### STAFF RECOMMENDATION 1007 Clearview Avenue August 17, 2016

**Application:** New construction—addition; Partial demolition  
**District:** Lockeland Springs-East End Neighborhood Conservation Zoning Overlay  
**Council District:** 06  
**Map and Parcel Number:** 08309013600  
**Applicant:** Matthew K. Spicher  
**Project Lead:** Melissa Baldock, melissa.baldock@nashville.gov

**Description of Project:** The application is to construct additions to both sides of the existing historic house. The project also involves altering window openings on the front and side facades.

Figures 3 and 4 are the front and left/west side facades.

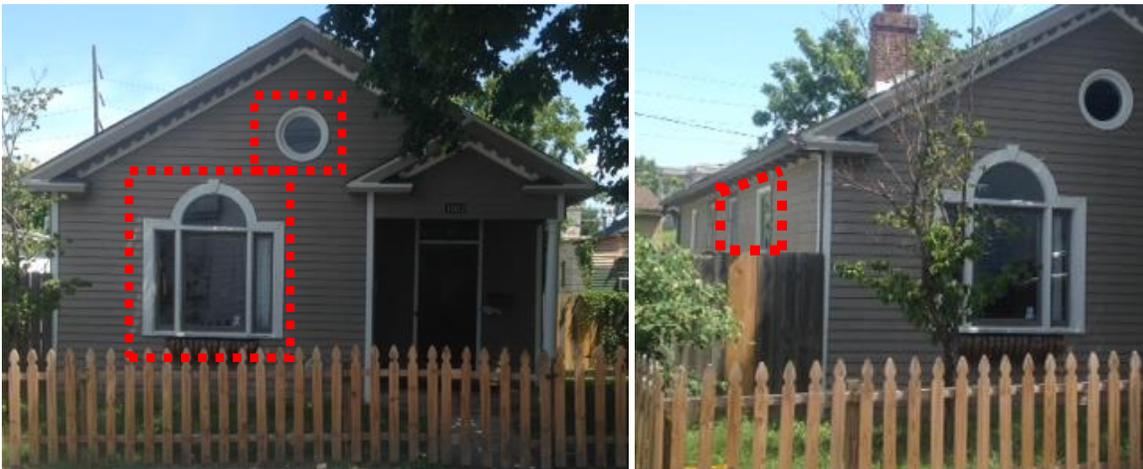
On the front façade, the applicant will be altering the front Palladian-style window into a double window opening (Figure 3). Staff finds this to be appropriate because the Palladian window is not typical for a house of this date and style, and was most likely installed in the 1960s or 1970s. The new window opening will be similar to the window openings at 1009 and 1011 Clearview Avenue, two houses that are a similar age and style as 1007 Clearview Avenue. Also, on the front façade, the applicant proposes to change the circular window opening into a square window opening. Like the Palladian window, the circular window is likely not original to the house, as it is atypical for a house of this age and style. The square window opening will have a width the same size as the diameter of the circular window opening.

On the left/west elevation, the applicant will be enlarging two window openings towards the front (Figure 4). The width of the openings will remain the same, but the window height will be altered from forty-eight inches (48") to sixty inches (60"). Staff finds that the alteration of these window openings to be appropriate because it is not clear if these window openings were altered when the other window openings were altered. The windows themselves are replacement windows. Also, their location on the side of the house will not greatly impact the historic integrity of the house.

Figure 5. The right/east elevation.

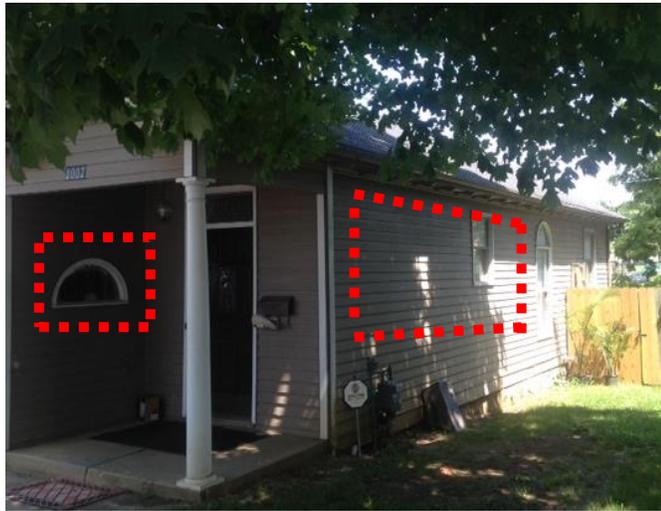
On the right/east elevation, the applicant will be changing a lunette window opening into a two foot by two foot (2' X 2') opening (Figure 5). Staff finds this to be appropriate because the lunette window opening is likely not original. It is atypical for a house of this age and style. Also on the right elevation, the applicant proposes to enlarge an existing opening and install two new window openings. Staff finds this to be appropriate in this instance because the house's window openings have been altered and it is not clear if any of the existing window openings are original.

The applicant does not intend to alter the existing porch column under this application. The existing porch column is not original, so replacement of it would be acceptable. If you compare Figure 1 (taken from the Property Assessor's website) and Figure 5, you can see that the existing column is a recent addition to the house.

① SOUTH (STREET) ELEVATION - NEW  
1/4" = 1'-0"

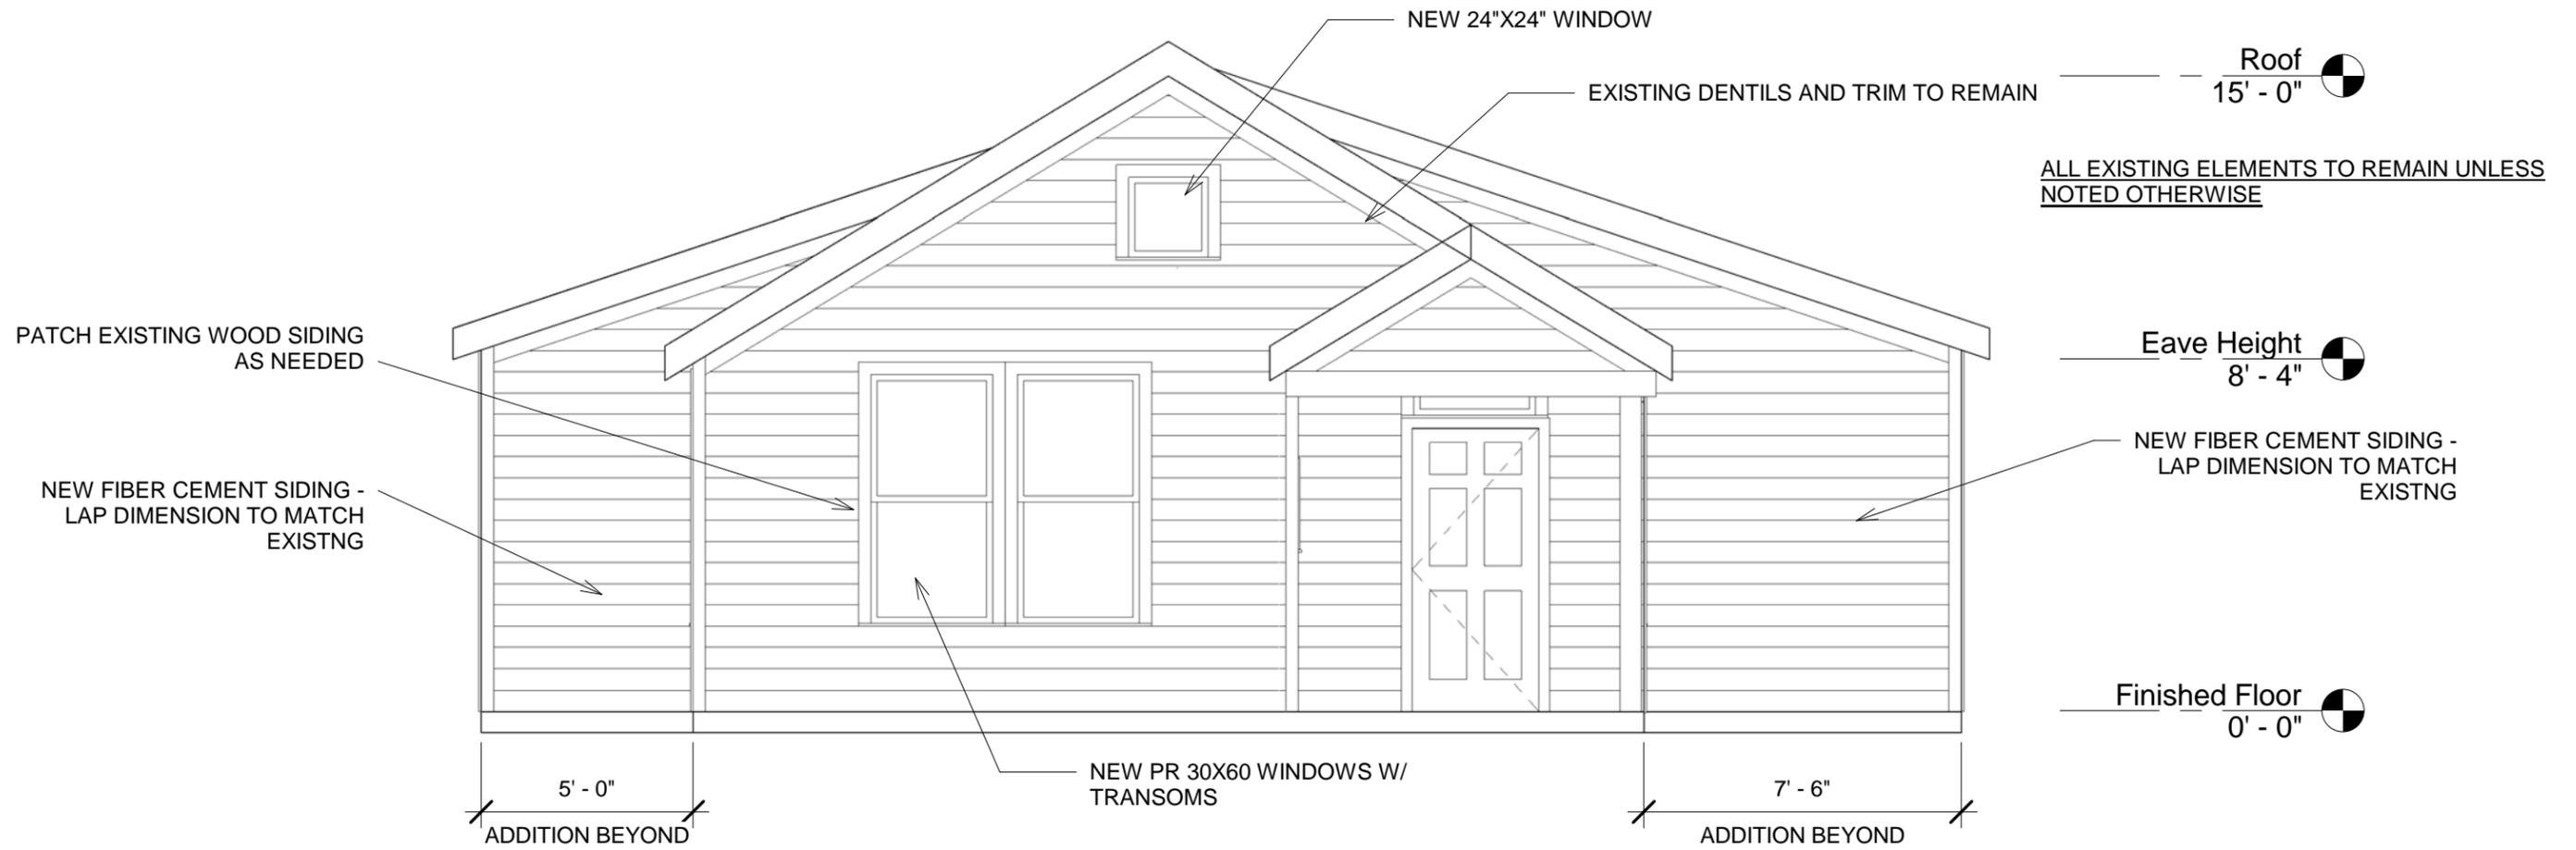
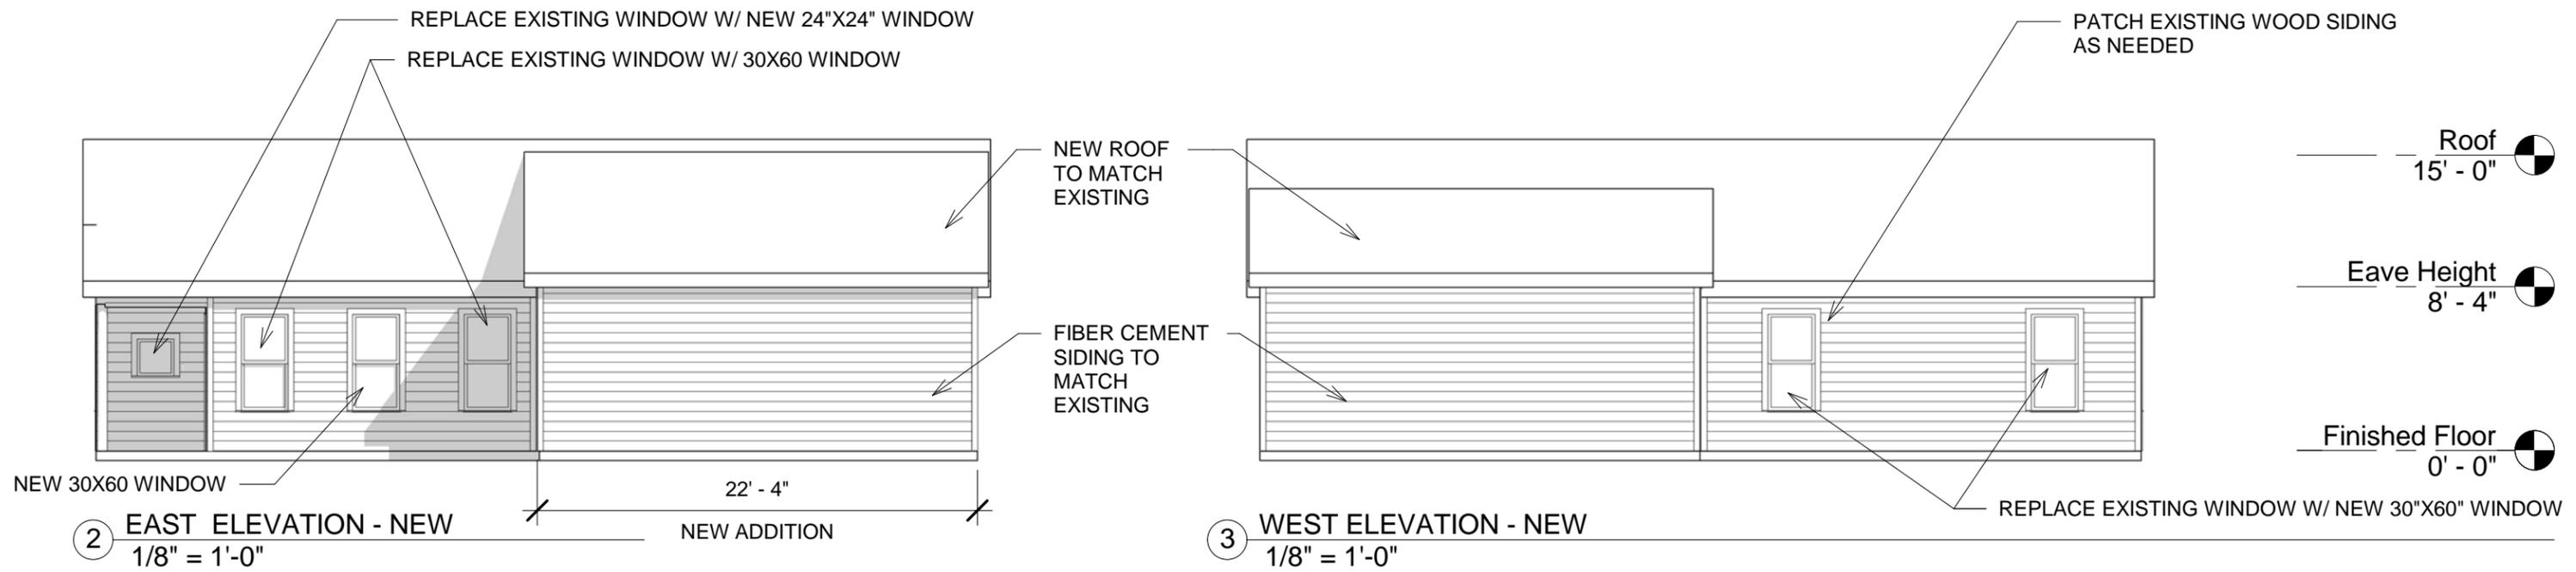
The new paired window opening on the front façade lacks a four to six inch mullion, and staff recommends that a four to six inch (4"-6") mullion be required between the two windows. With this condition, staff finds the addition's proportion and rhythm of openings to meet Sections II.B.7. and II.B.10. of the design guidelines.

Appurtenances & Utilities: No changes to the site's appurtenances were indicated on the drawings. The location of the HVAC and other utilities was also not noted. Staff asks that the HVAC be located on the rear façade. Staff also recommends that the applicant return to MHZC staff for approval for any handicap access parking at the front of the lot.

1. The front paired window have a four to six inch (4"-6") mullion in between the windows;
2. Staff approve the final details, dimensions and materials of windows and doors prior to purchase and installation;
3. Staff approve the roof color and masonry color, dimensions and texture; and
4. The HVAC be located behind the house.
